Document Title	List of known Issues of Secure Hardware Extensions
Document Owner	AUTOSAR
Document Responsibility	AUTOSAR
Document Identification No	971
Document Status	published
Part of AUTOSAR Standard	Foundation
Part of Standard Release	R21-11

Figure 1

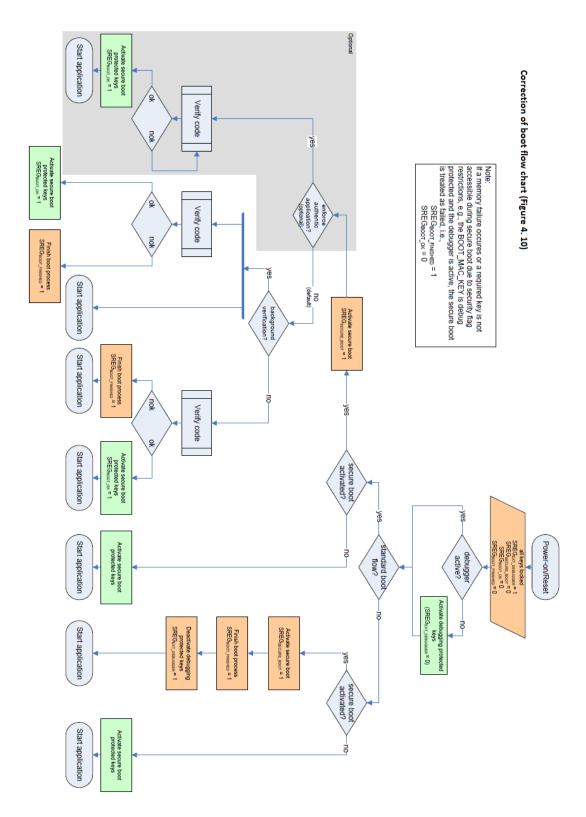
No.	Date	Severity	Problem Description	Location
1	2009-07-31	erratum	CMD_EXPORT_RAM_KEY can also issue error code ERC_KEY_NOT_AVAILABLE.	Section 4.7.9 Table 4.6
			Note: The description of the command and the overview table were missing the information.	
2	2009-07-31	erratum	CMD_GET_ID may not issue error code ERC_KEY_NOT_AVAILABLE since key protection flags are not evaluated	Section 4.7.17 Table 4.6
			Note: The description of the command and the overview table indicate an error code that cannot be emitted by the command.	
3	2009-07-31	erratum	CMD_EXPORT_RAM_KEY reads UID Note: The command also needs to access the UID to calculate the messages. The referenced table is missing the corresponding information (X = used by function).	Table 4.4
4	2009-07-31	erratum	The flag SREG.EXT_DEBUGGER has not to be set if the secure boot failed, see Figure1 of this errata sheet for a corrected flow chart.
